Access Compliance Report

Public Rights-of-Way

(Curb Ramps)

Intersection ID: 49790	Main Street: FESCUE_CT	Cross Street: BARLEY_LN	Location:	E
ADA ID: 77A104A632EA	Ramp Type: Perp	Initial Pass/Fail: Pass	Overall Compliance: No	Severity Score: 0

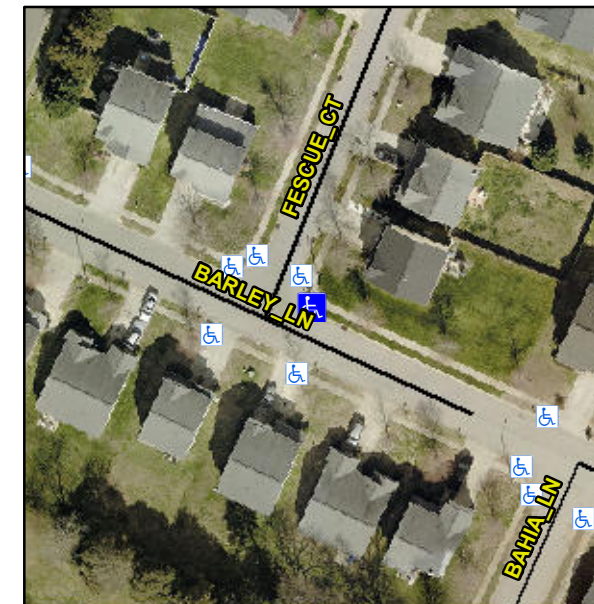
Not Found, R304.2.2-Perp, R304.3.2-Para

Compliance	Description	Data	Compliance	Description	Data
N/A	Ramp Length (in)	47.5	Yes	Ramp Slope (%)	6.5
Yes	Ramp Width (in)	48.0	Yes	Ramp XSlope (%)	0.9
N/A	Flare Type LT	Sloped	N/A	Flare Type RT	N/A
N/A	Flare Slope LT (%)	1.4	Yes	Flare Slope RT (%)	0.8
N/A	Flare Traversable LT?	Yes	N/A	Flare Traversable RT?	Yes
Yes	Landing Length (in)	48.5	Yes	DWS Provided?	Yes
Yes	Landing Width (in)	48.0	Yes	DWS Contrast?	Yes
No	Landing Slope (%)	2.4	Yes	DWS Length (in)	24.5
Yes	Landing X Slope (%)	1.6	Yes	DWS Full Width?	Yes
N/A	Landing Curb? (Y/N)	No	Yes	DWS Offset (in)	1.5
N/A	Shared Landing?	No			
Yes	Gutter Ponding?	No	Yes	Gutter Slope (%)	2.7
Yes	Gutter Lip Ht (in)	0.0	Yes	Gutter X Slope (%)	0.1
N/A	Painted X Walk1?	No	N/A	Painted X Walk2?	N/A
	X Walk 1 Direction	To SW		X Walk 2 Direction	N/A
N/A	X Walk 1 Width (in)	N/A	N/A	X Walk 2 Width (in)	N/A
	X Walk 1 Slope (%)	4.1		X Walk 2 Slope (%)	N/A
	X Walk 1 X Slope (%)	0.3		X Walk 2 X Slope (%)	N/A

Remove & Replace Entire Ramp.
